LONG ISLAND LIGHTING COMPANY

SHOREHAM NUCLEAR POWER STATION

SNRC-1141

Fire Protection
Shoreham Nuclear Power Station - Unit 1
Docket No. 50-322

FLOW DIAGRAM
WATER FIRE PROTECTION SYSTEM
SHOREHAM NUCLEAR POWER STATION
UNIT 1
LONG ISLAND LIGHTING COMPANY
 STONE & WEBSTER ENGINEERING CORPORATION
 BOSTON, MASS.
 LILCO
 DRAWING NUMBER **M-10661-12**

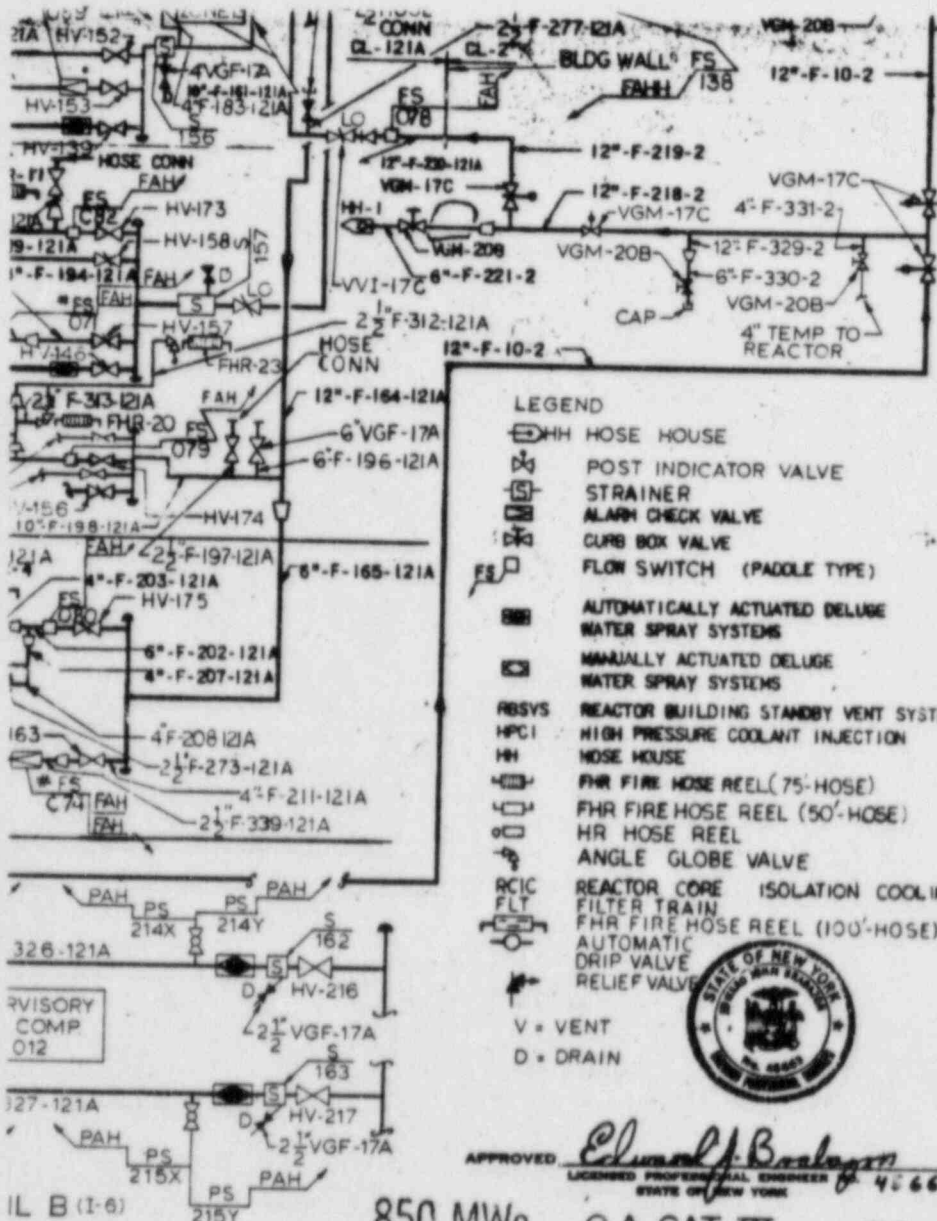
Unresolved Item 84-46-14 - Single Header in the Reactor Building

Branch Technical Position 9.5-1 Appendix A requires that a single failure not impair the fire suppression system. LILCO complies with the BTP. With respect to the single header in the Reactor Building, LILCO has utilized the guidance of MEB-1 in determining that the postulated pipe failure for this moderate energy system would result in a crack producing a leakage of 165 gpm. Such a failure would not impair the fire suppression system in the Reactor Building since each fire pump has a rated capacity of 2500 gpm.

The single header configuration utilized at Shoreham was inspected and reviewed by the NRC during the FSAR review process (1979-1980). As a result of a staff question (FHAR Question 1), a redundant feed to the Reactor Building was installed. With this modification, the Staff accepted the design of Shoreham's fire header for the Reactor Building.

A copy of drawing M-10661, Rev. 12, "Water Fire Protection System" is enclosed, showing the water suppression system in the Reactor Building. Shoreham Technical Specifications require that if the fire suppression water system becomes inoperable, a backup fire suppression water system must be established within 24 hours. From the enclosed figure it can be seen that certain non-postulated circumferential breaks in the Reactor Building could be isolated and backup suppression established via hose reels or extinguishers. Depending on the location, certain other non-postulated breaks could render the fire suppression system temporarily inoperable. If backup suppression could not be established, LILCO would bring the plant to the shutdown condition.

The FSAR has always contained the single header configuration. The NRC accepted this configuration and LILCO believes that a backfit is not justified.
